ADDENDUM #4

Project	TA Blakelock High School Renovations	Project No.	2215-B
Location	1160 Rebecca Street, Oakville, ON	Date of Issue	2024 04 29
Owner	Halton District School Board	File	2215/7.1.3

Mechanical Addendum No. 03

1. Drawing M4/M101 – PROPOSED PLUMBING AND DRAINAGE PLAN

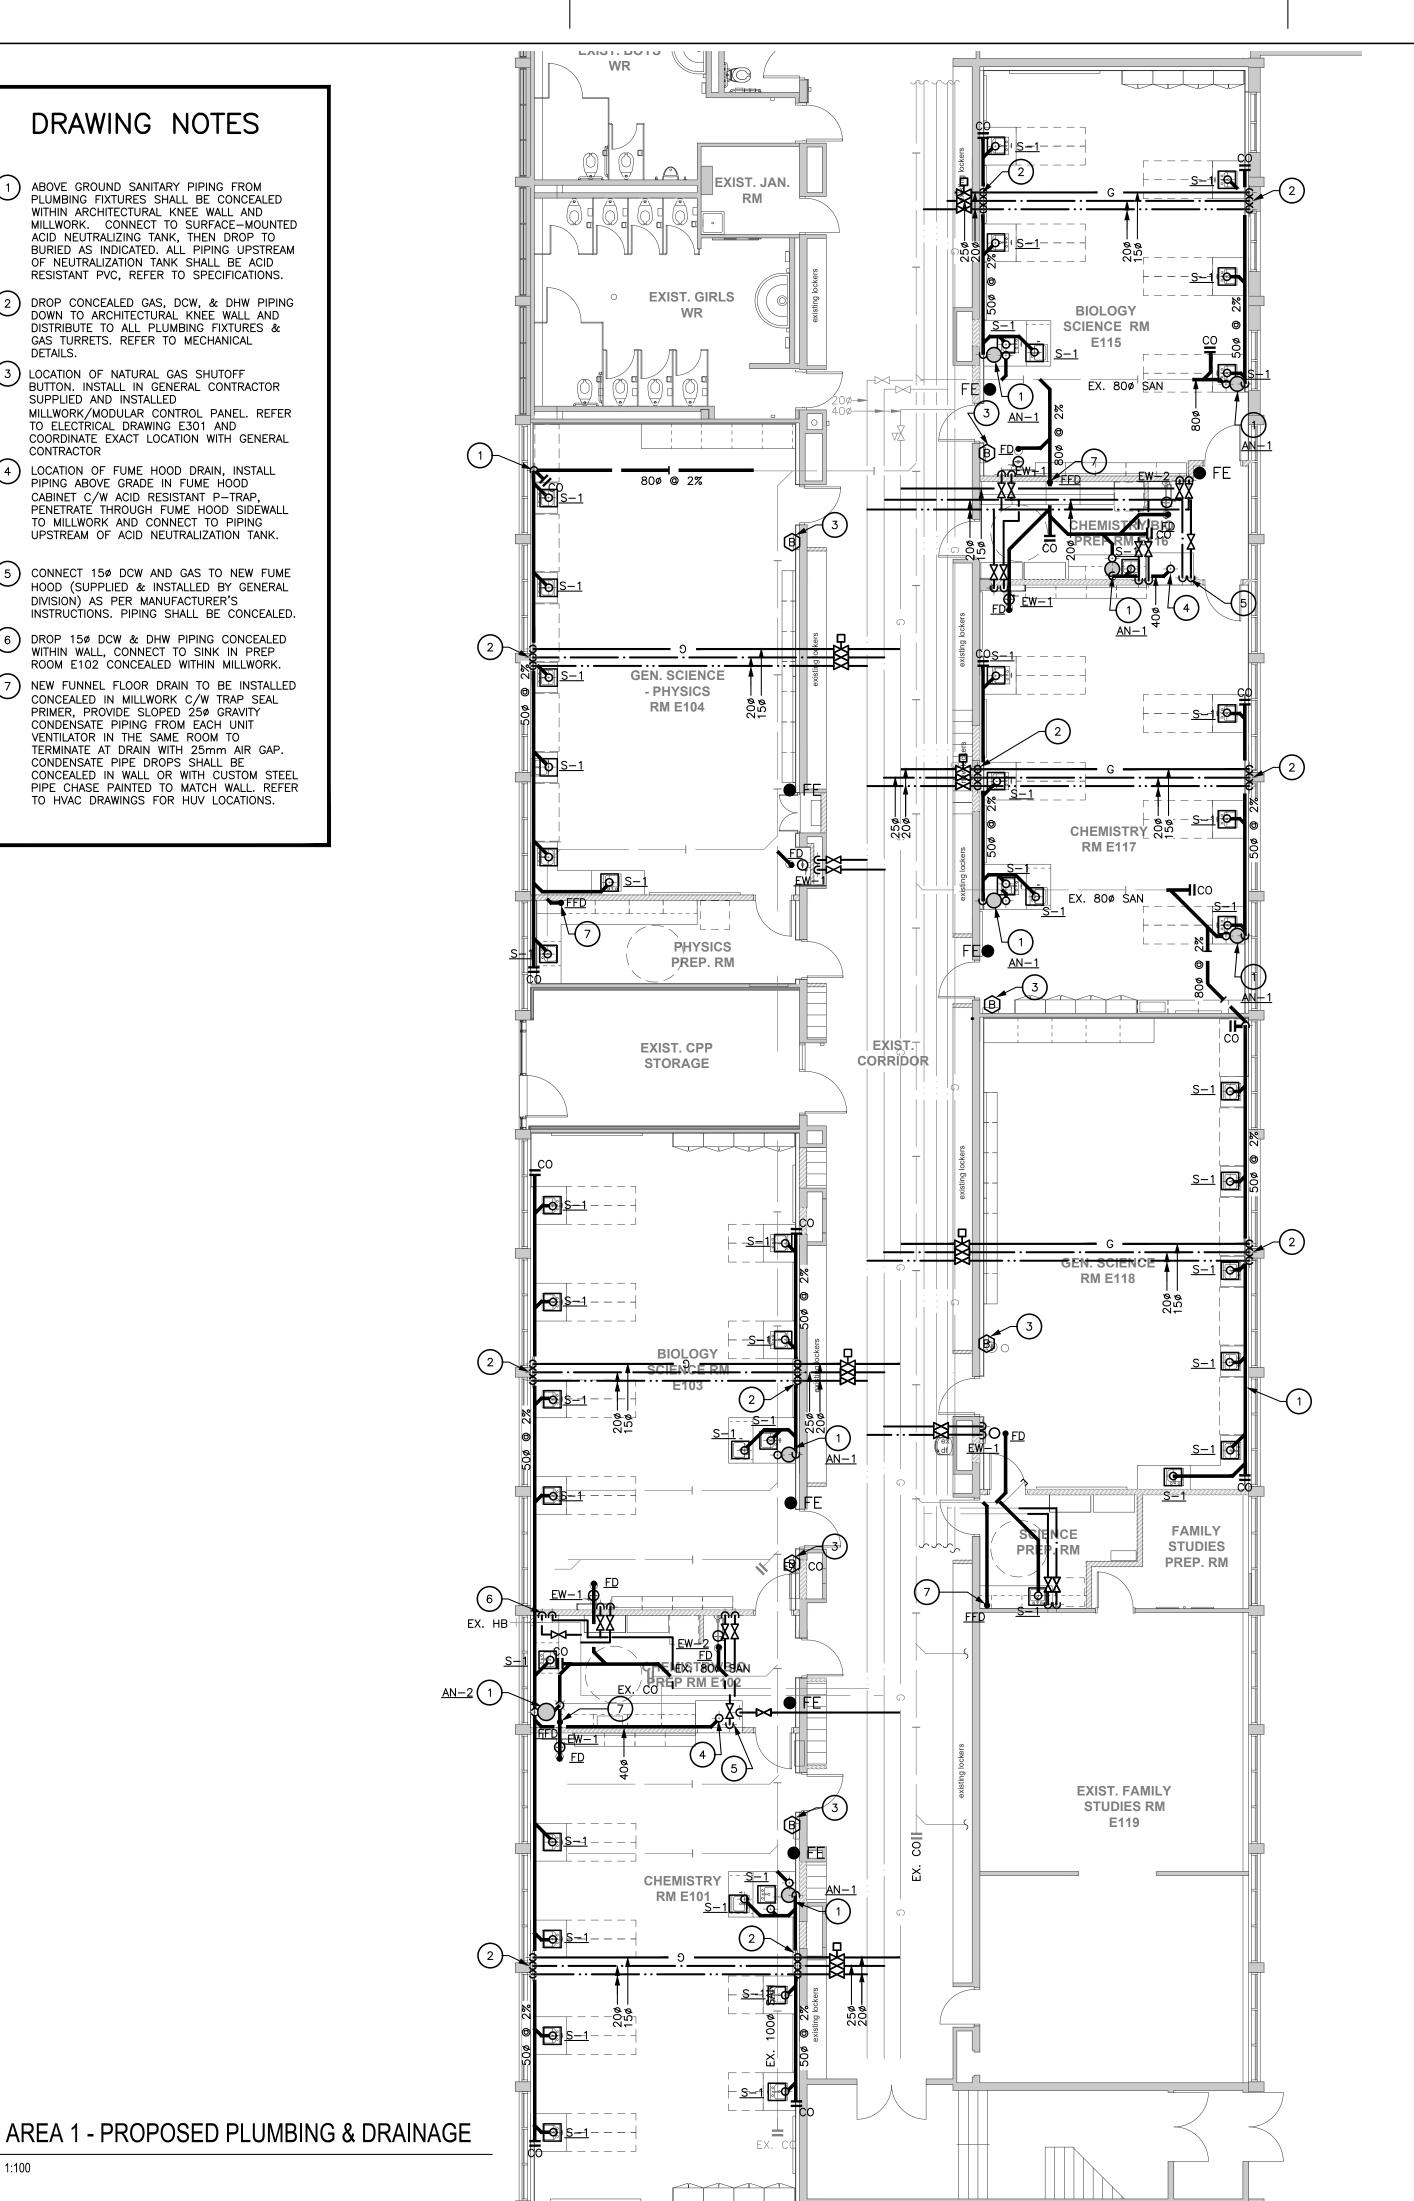
- .1 Drawing is issued with this addendum. Modifications include, but are not limited to the following:
 - .1 Refer to extent of note #3. The length of pipe insulation to be replaced shall be the classroom and adjacent prep room. This work shall be coordination on site wit the abatement contractor.
